Comments by Tom Clements, Director of Savannah River Site Watch (SRS Watch) in response to Federal Register Notice of December 16, 2020: "Notice of Intent To Prepare an Environmental Impact Statement for the Surplus Plutonium Disposition Program"
<https://www.govinfo.gov/content/pkg/FR-2020-12-16/pdf/2020-27674.pdf>

Programmatic Environmental Impact Statement (PEIS) Needed on Plutonium Disposition and All Plutonium Waste Streams Designated for the Waste Isolation Pilot Plant (WIPP) - including from Plutonium Disposition, Proposed SRS Plutonium Bomb Plant (PBP) & Fuel Fabrication for Versatile Test Reactor (VTR)

Figure 1. Breakdown of KAMS Surplus Plutonium Inventory

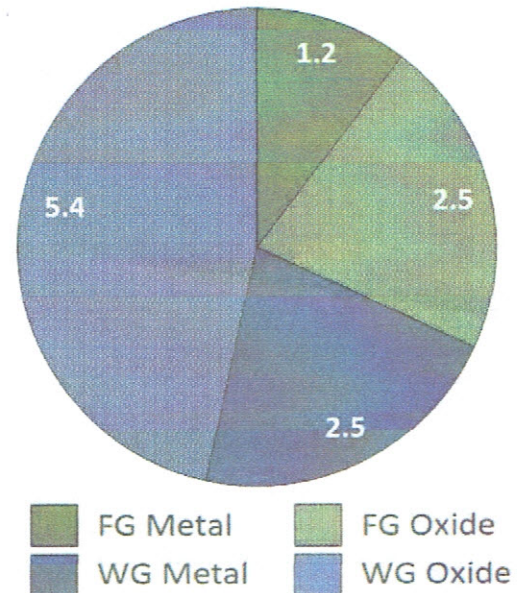
How much of the approximately 11.5 metric tons of plutonium now stored at SRS - see attached DOE document confirming this amount - will undergo disposition? Will this material already at SRS be processed before more plutonium is brought into South Carolina? What is the schedule for bringing more plutonium into South Carolina, processing it and shipping it out?
